REGIONAL REVIEW NOTIFICATION

Name of Proposal:2023 The Grove DRI 3974Submitting Local Government:Henry CountyDate Opened:July 14, 2023Deadline for Comments:July 29, 2023Date to Close:July 31, 2023

Description: A DRI review of a proposal to construct a mixed-use development with 7,160 residential units (including single-family homes, townhomes, senior residences, and multi-family apartments), 1,990,000 SF of commercial/retail space, 100,000 SF of village retail space and 180 hotel rooms on a 1,277-acre mostly wooded site fronting Shoal Creek off of Lovejoy Road and Highway 19/41 in Henry County.

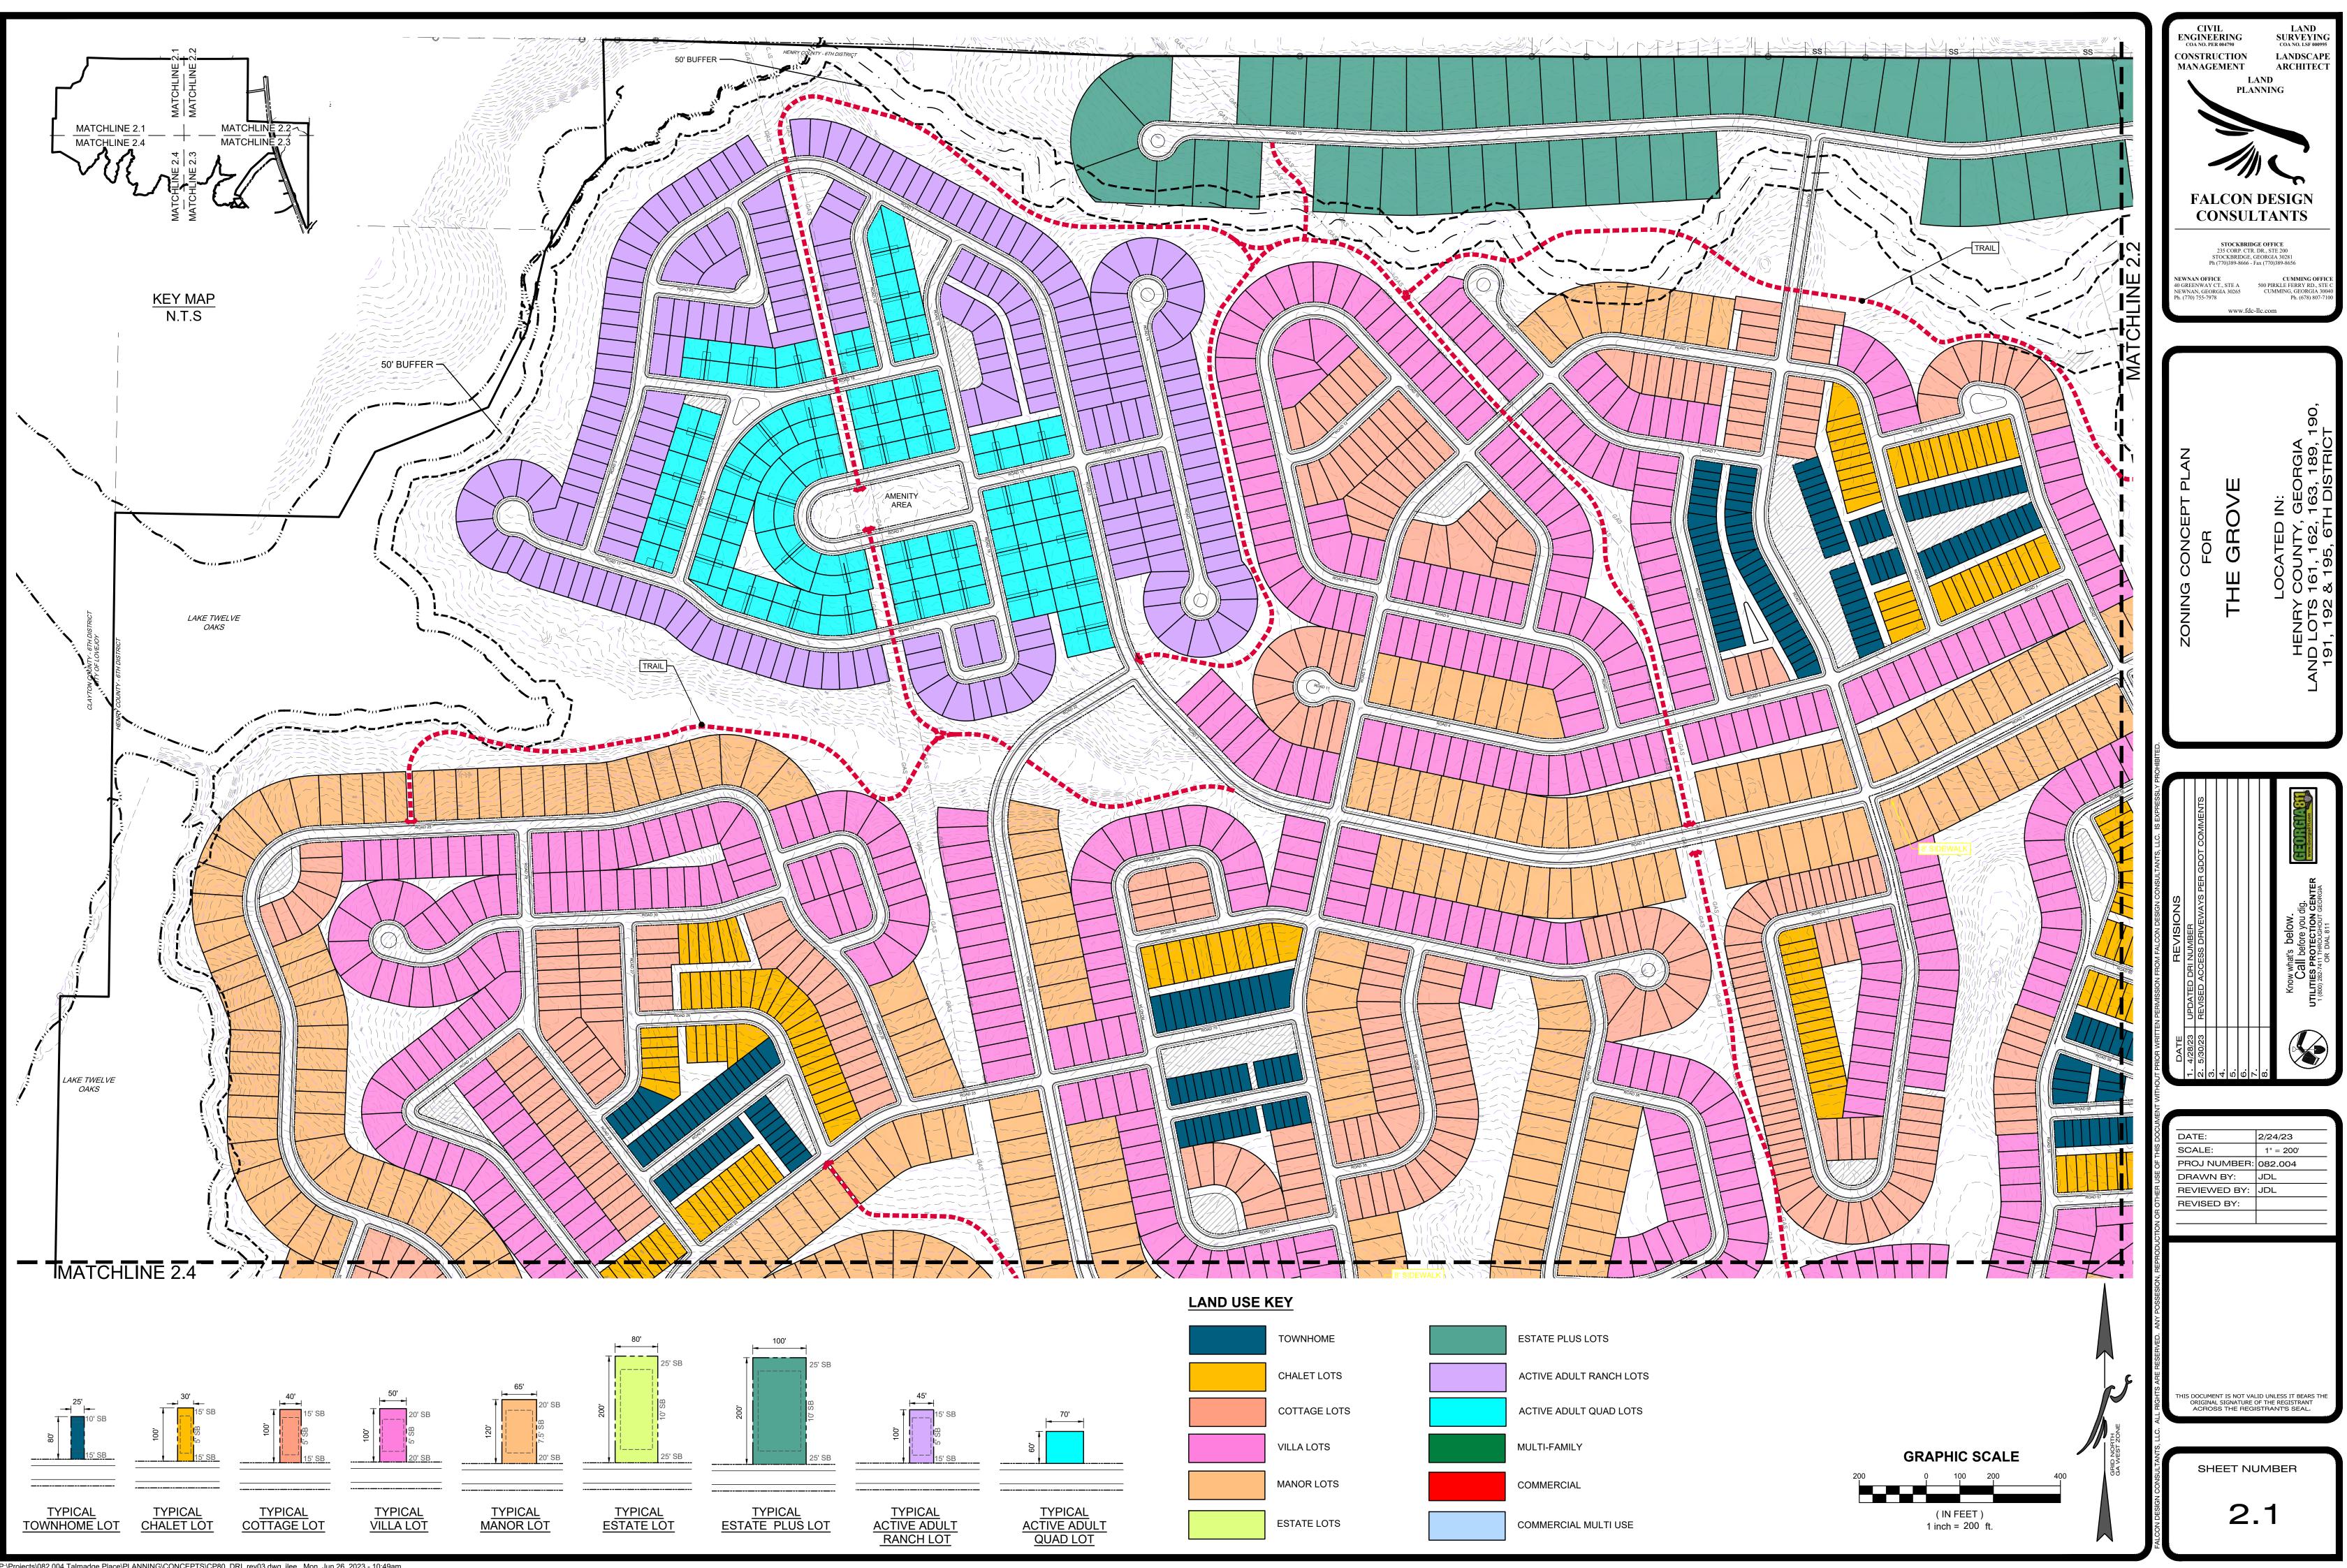
Approximately 150 of the project's total 1278 acres will be retained as open space. The project could be better aligned with Rural Areas policies by utilizing more concentrated development and providing more conservation and open space especially around water elements.

The project includes extensive frontage on the Shoal Creek Reservoir, labeled on the site plan as "Lake Talmadge," which is owned and operated by the Clayton County Water Authority for water supply storage.

Plans show 100'/150' buffers on the portions of the project bordering the Shoal Creek Reservoir. Henry County would need to adopt a revision to their County small water supply watershed protection ordinance for these buffers to be formalized.

The Shoal Creek Reservoir, labeled on the map as "Lake Talmadge," is owned and operated by the Clayton County Water Authority for water supply storage. The project's final design will need to be coordinated as required with the Clayton County Water Authority.

The project's ultimate design and implementation will need to be carefully coordinated as required with the Clayton County Water Authority.
